## AMENDMENTS TO THE DRAWINGS

In response to the Office action identified above,  
Fig. 2-5 has been revised. One clean copy of Fig. 2-5  
5 has been provided along with one marked copy showing  
the changes made.

Fig. 2

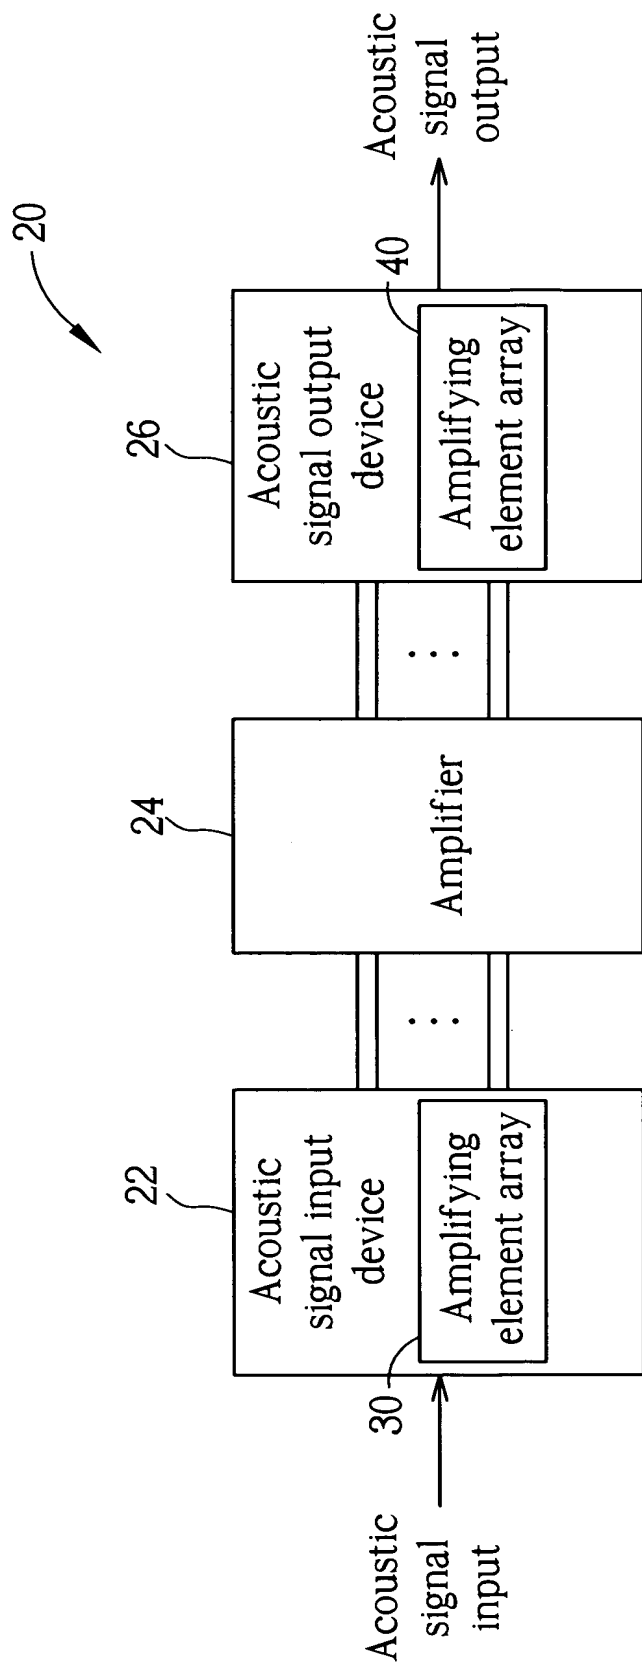
In Fig. 2, the acoustic signal input device (22)  
comprises an amplifying element array (30), and the  
acoustic signal output device (26) comprises another  
10 amplifying element array (40). The hearing aid device  
receives an acoustic signal input and outputs an acoustic  
signal output.

Fig. 3

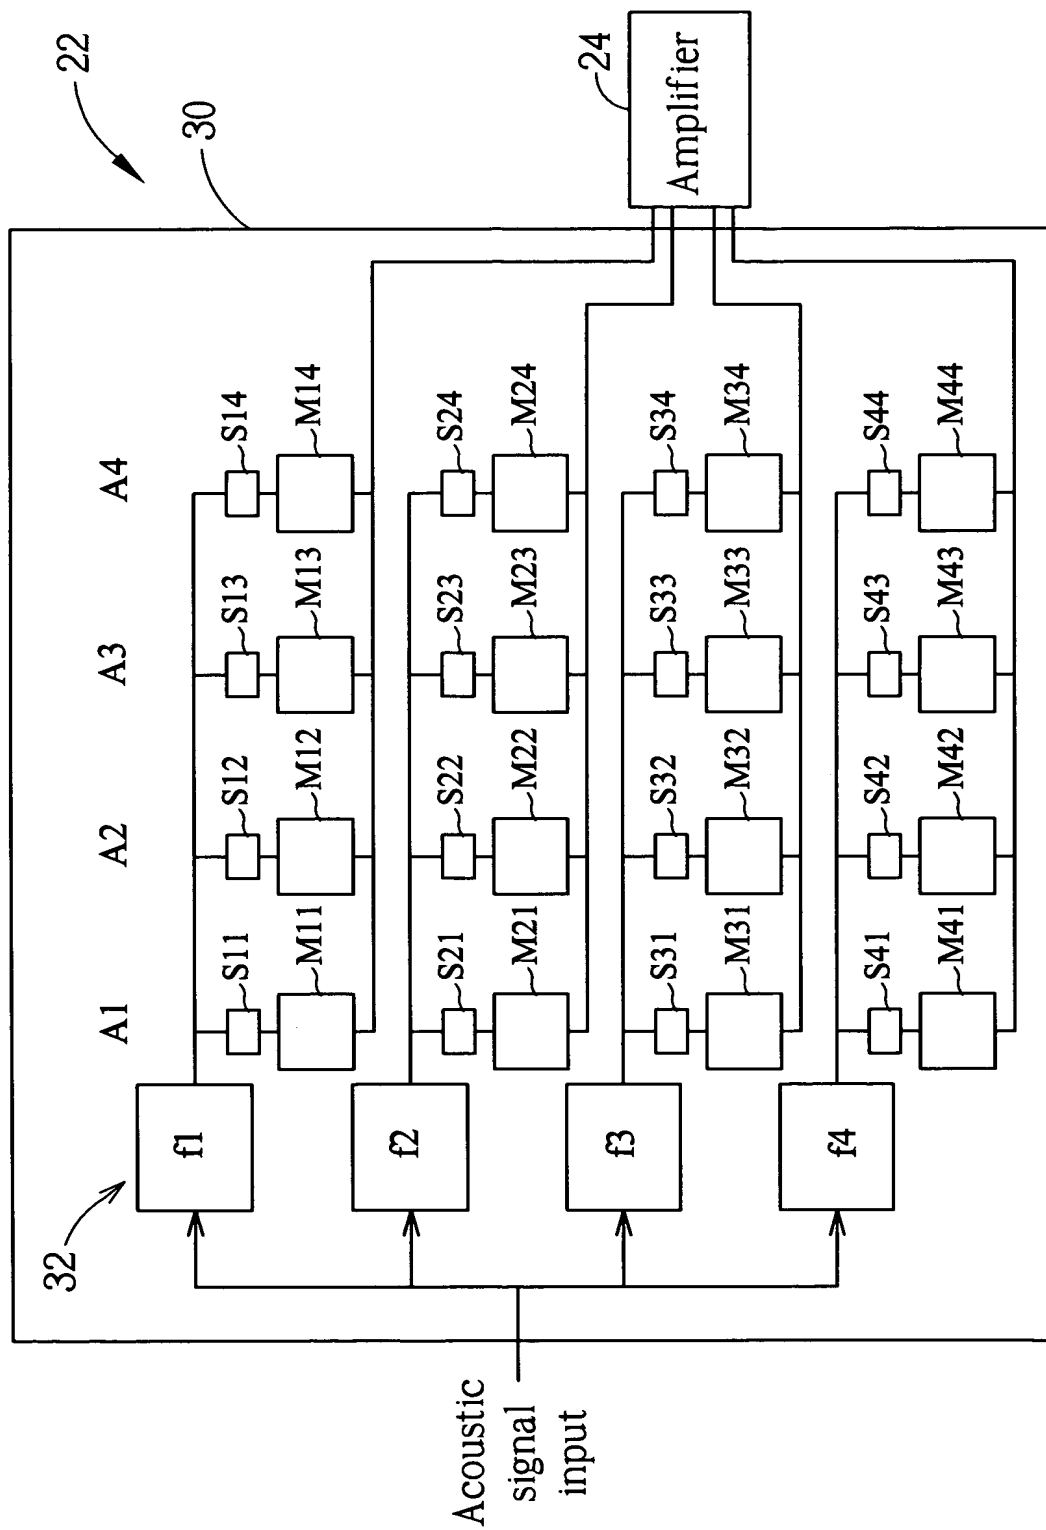
In Fig. 3, the acoustic signal input device (22) receives  
an acoustic signal input and comprises an amplifying element  
15 array (30).

Fig. 4

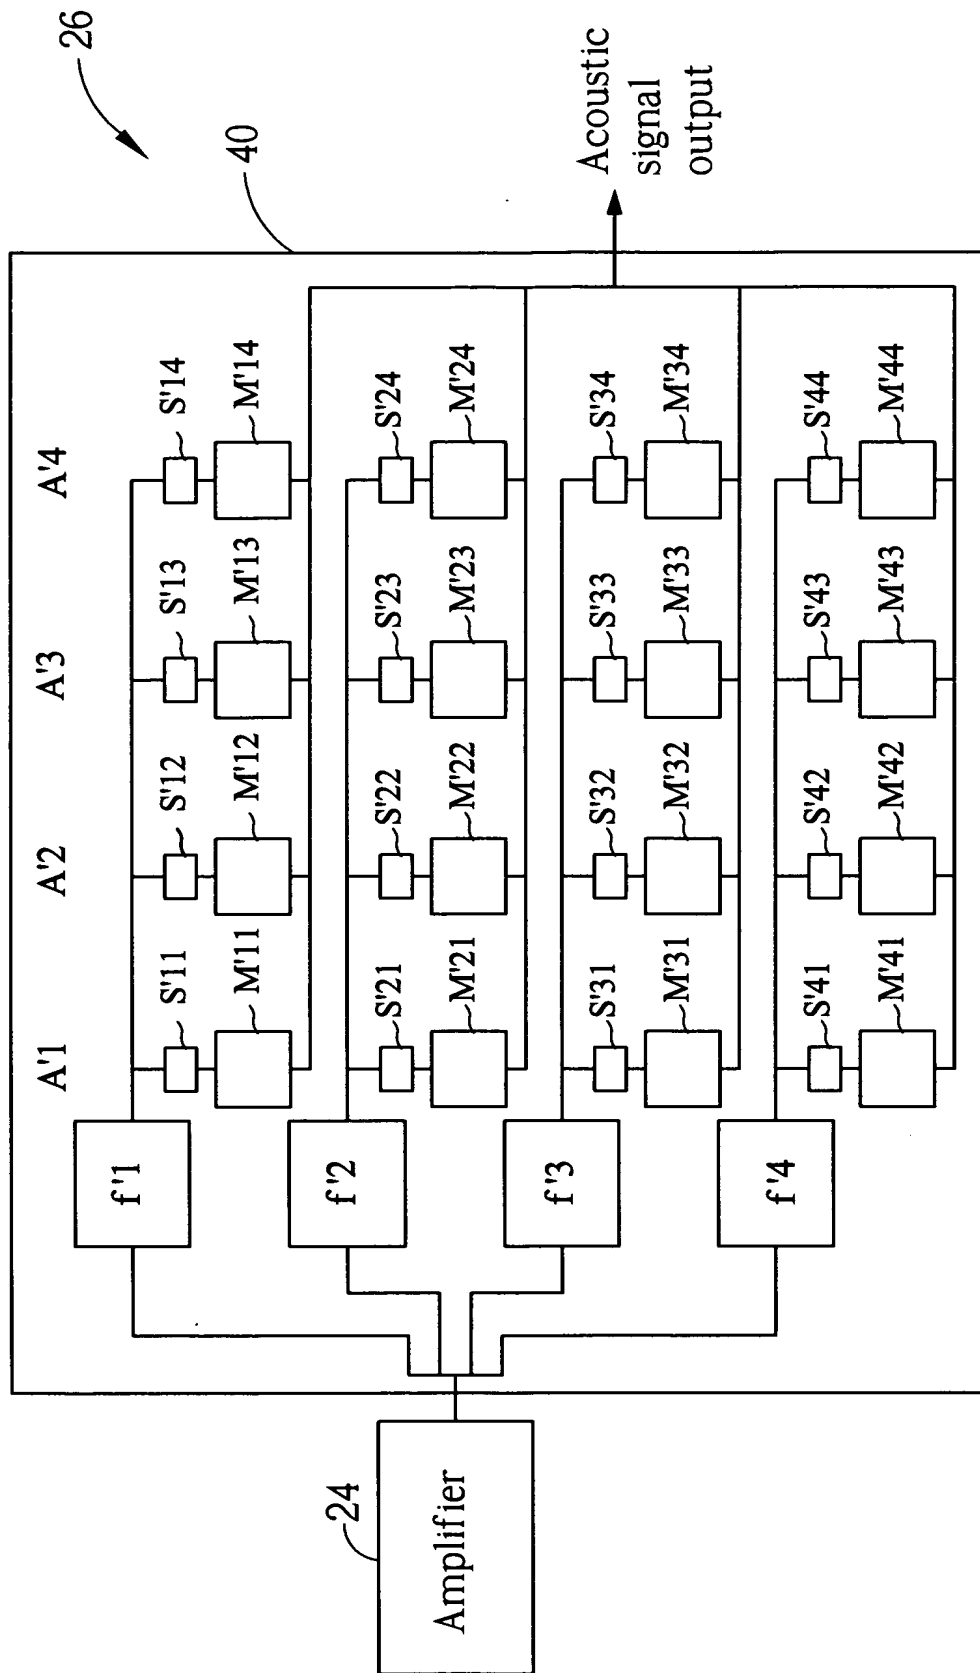
In Fig. 4, the acoustic signal output device (26) comprises  
an amplifying element array (40) and outputs an acoustic signal  
output.

Fig. 5

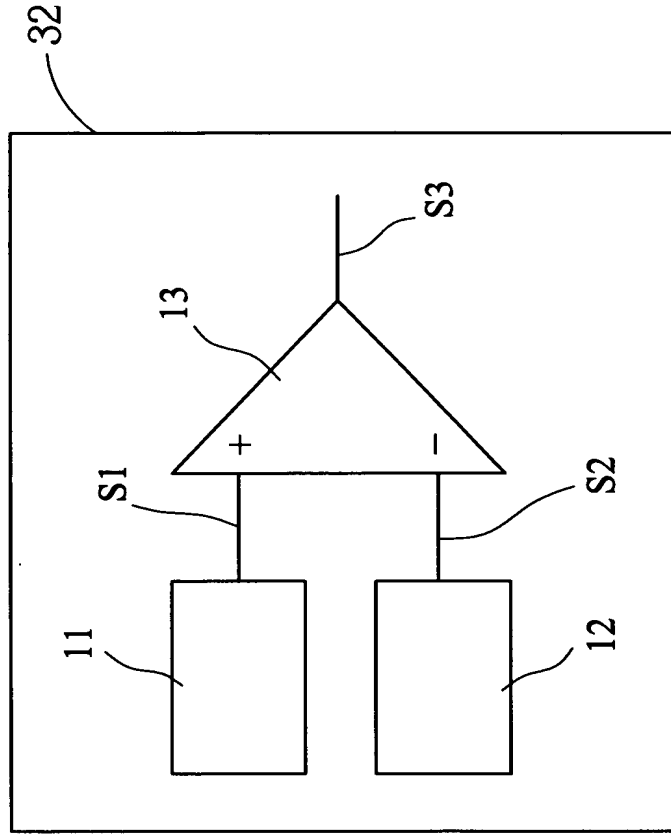
In Fig. 5, the bandpass filter (32) comprises two acoustic  
20 receiving units (11), (12) with different resonant  
frequencies and a differential amplifier (13).
